TO: Madeleine Reinke, Kimley-Horn and Associates, Inc.
FROM: Cynthia Thye, Planner 1
DATE: March 19, 2026
SUBJECT: SP25-119: Lincoln Professional Park L2 - 7 Brews Coffee – Site Plan
Review Comments 03

Description: Lincoln Professional Park L2 - 7 Brews Coffee

2 EXTERIOR ELEVATION - WEST W/ COOLER
3/8" = 1'-0"

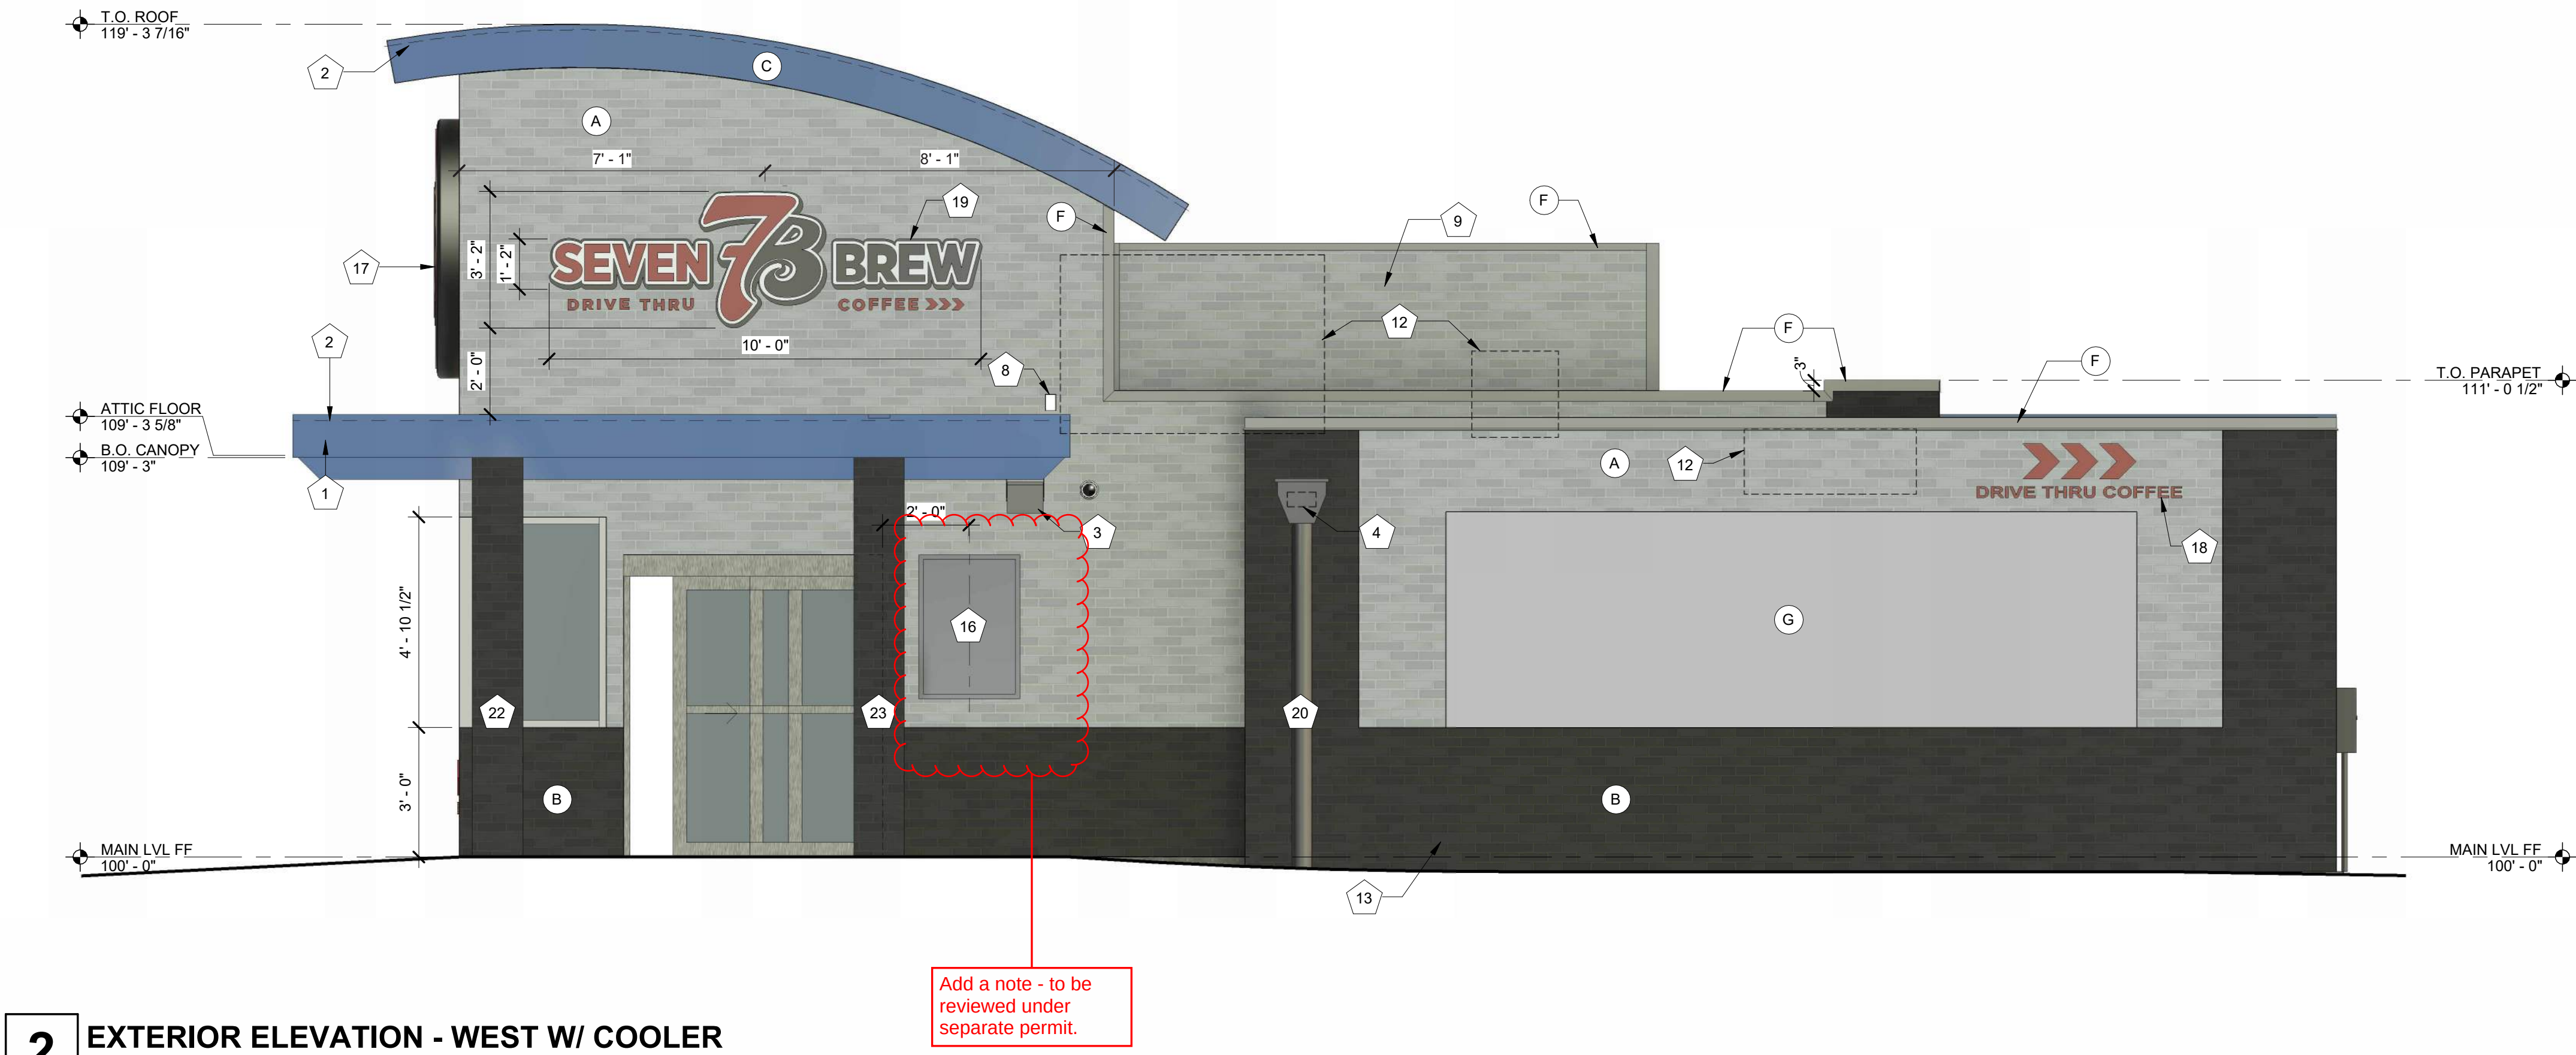
4. For west elevation add note sign to be reviewed under separate permit.

3 EXTERIOR ELEVATION - LEFT MATERIALS

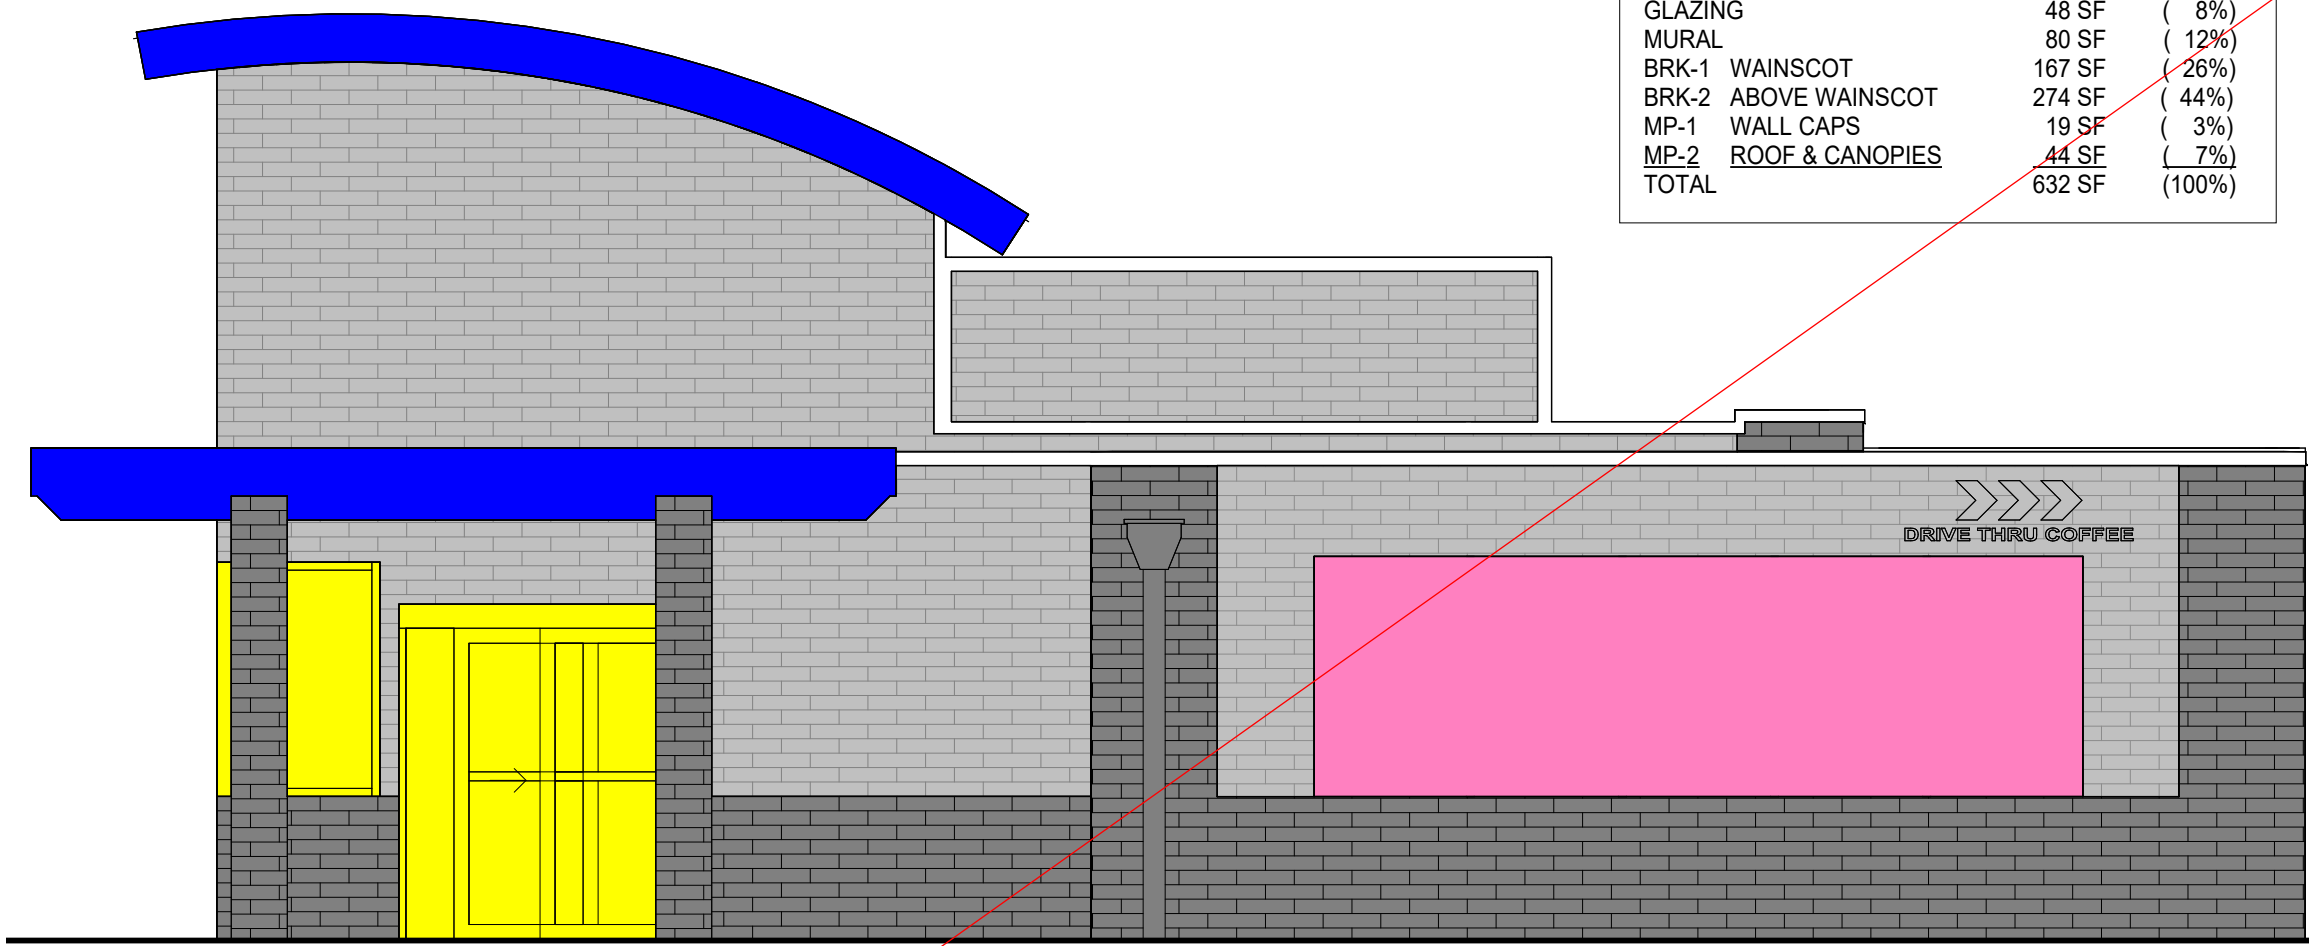
7. Mural does not meet requirements for art. This proposed mural uses branding posted on the company website. Branding is not allowed for architectural articulation nor murals. This architectural element is very important since no elevation on this plan meets the fenestration requirements for a commercial building at 40% for buildings less than 100 feet in length.

Revise. This uses branding posted on the company website. Branding is no allowed for architectural articulation. This is considered a sign and would need to be applied for under a separate permit.

Per DDS fenestration requirements for commercial building less that 100 feet are 40%, so this element is very important.

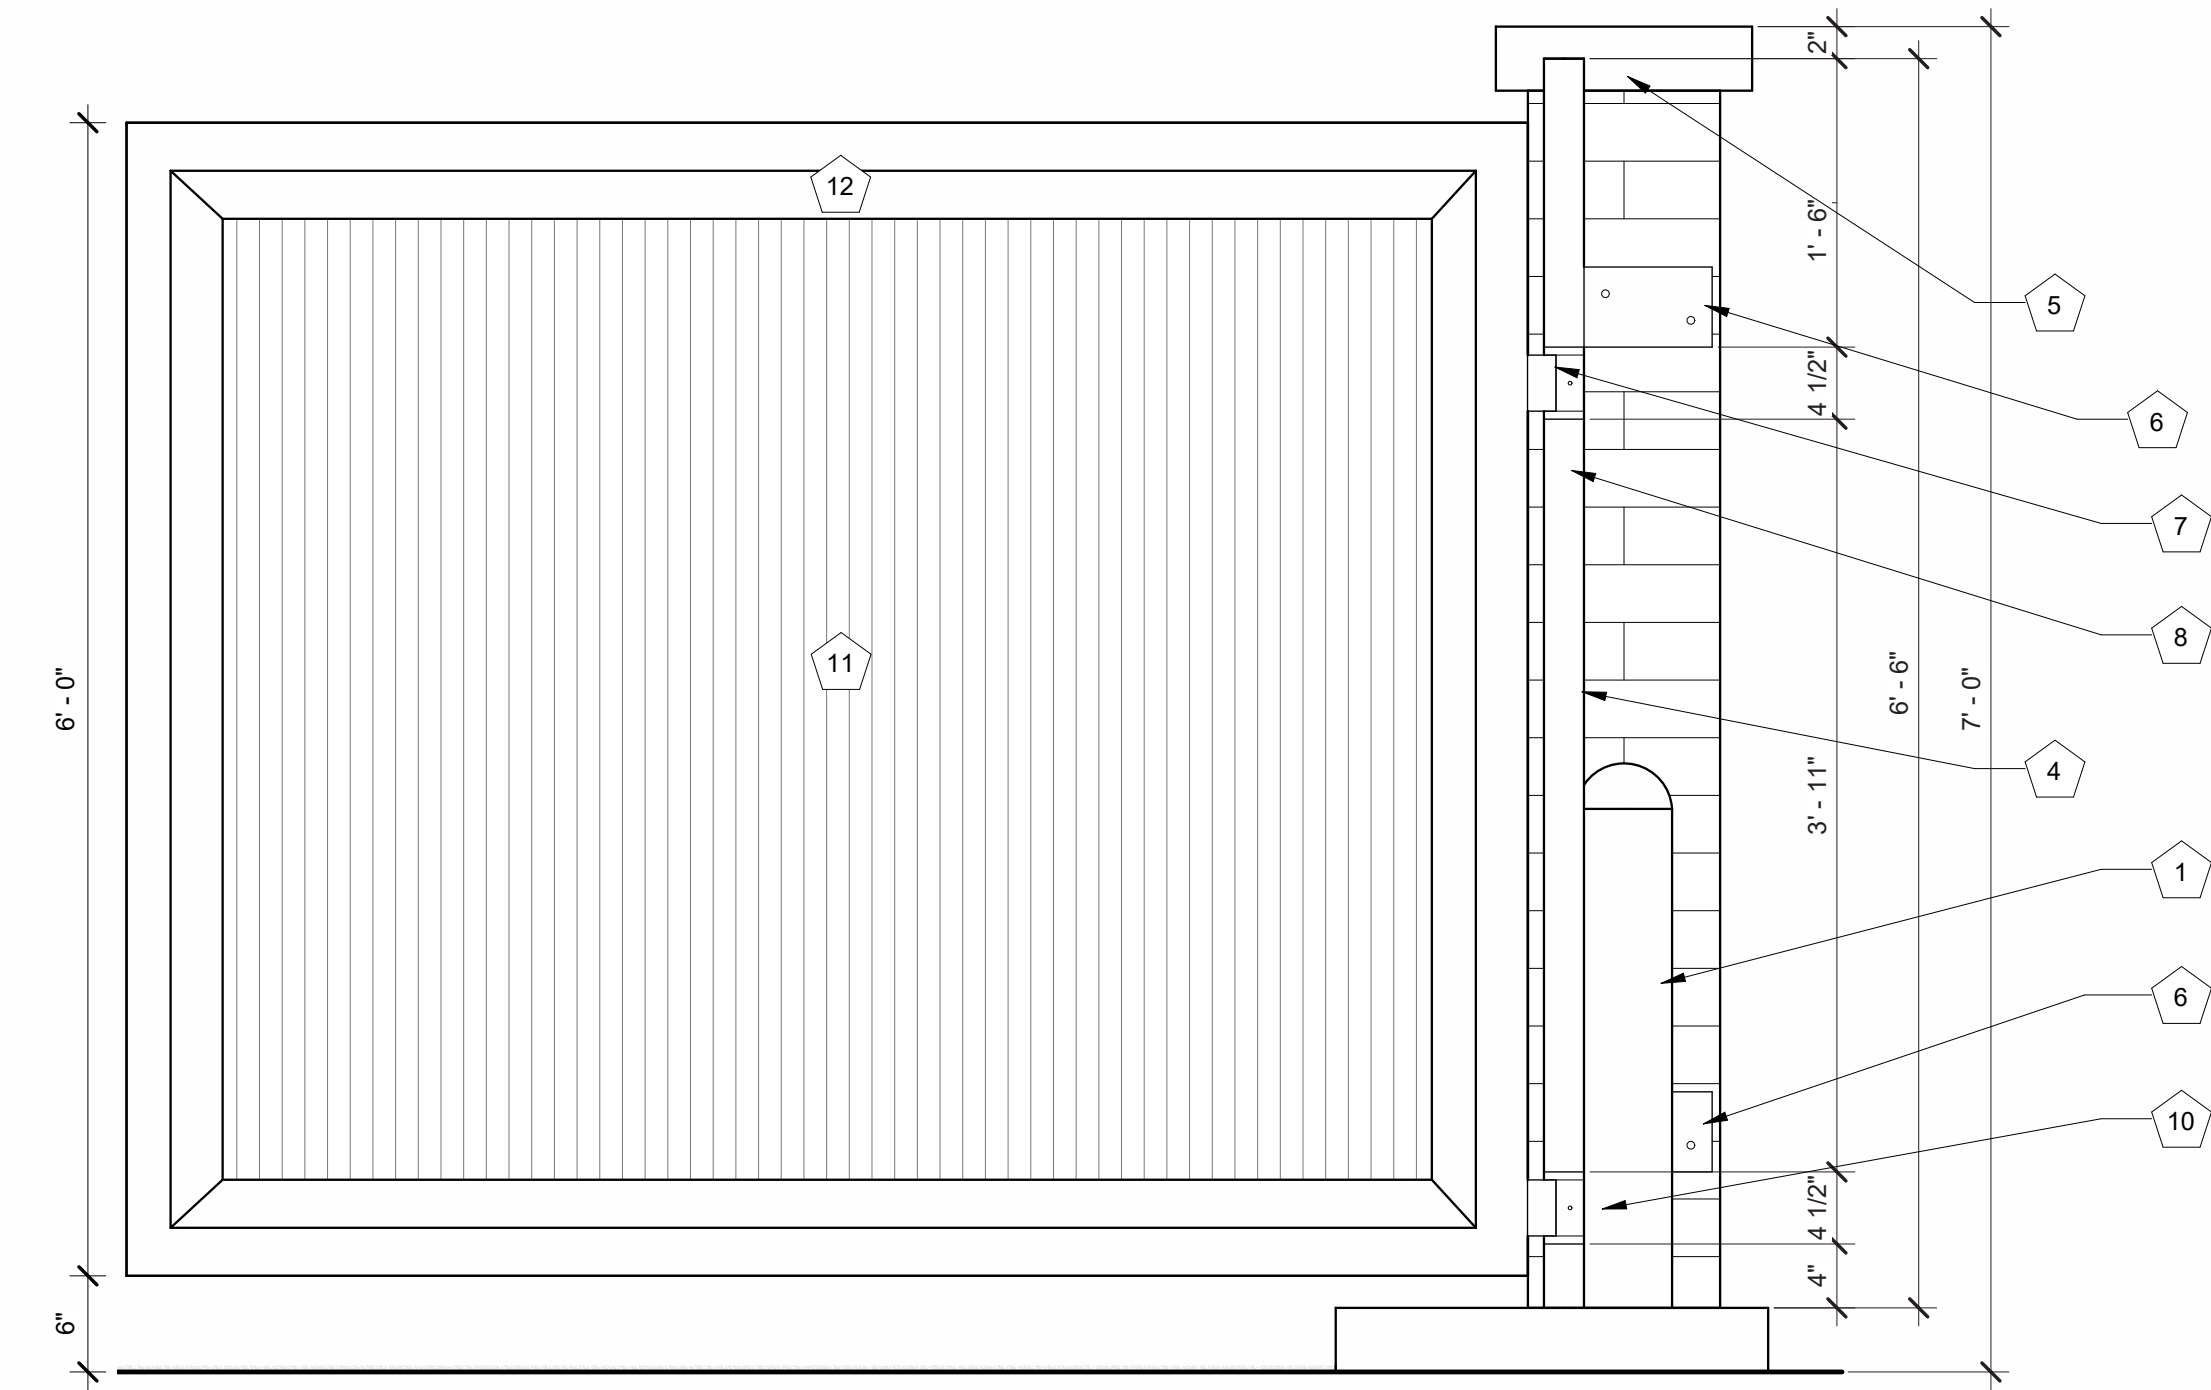
6. Add cardinal direction to Sheet A2.4.

Revise - Use cardinal directions (north, east, south, west)
